153/19 ENU 2796

Symptom - Body Exterior - Hybrid Vehicle Cannot be Charged Using 208 V Main Power Supply. Install New Software on Porsche Mobile Charger (2nd generation). (SY 153/19)

Revision: This bulletin replaces bulletin Group 2, 153/19, dated March 18, 2020.

Vehicle Type: Panamera Hybrid (971)

Individual parts of Porsche mobile charger

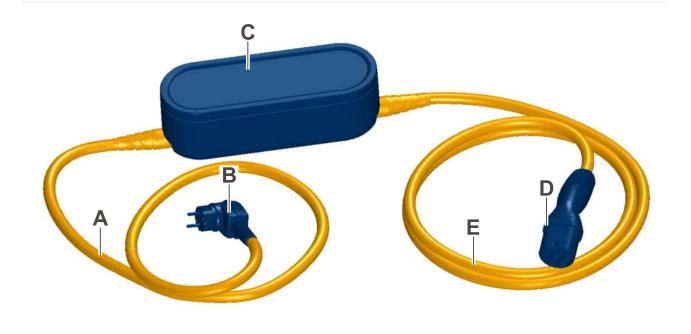
Information: Hybrid vehicles with a Porsche mobile charger cannot be charged using the 208 V mains

Install new software on the Porsche mobile charger (2nd generation).

- 1 Disconnect Porsche mobile charger from the power supply.
- 2 Unplug the vehicle plug from the vehicle charge port.
- 3 Connect diagnostic adapter for high-voltage charging system to the Porsche mobile charger and 9900 - PIWIS Tester 3.
- 4 Connect diagnostic adapter for high-voltage charging system, Porsche mobile charger and 9900 - PIWIS Tester 3 to the power supply.

5 Switch on Porsche mobile charger ⇒ Porsche mobile charger - "arrow" -.
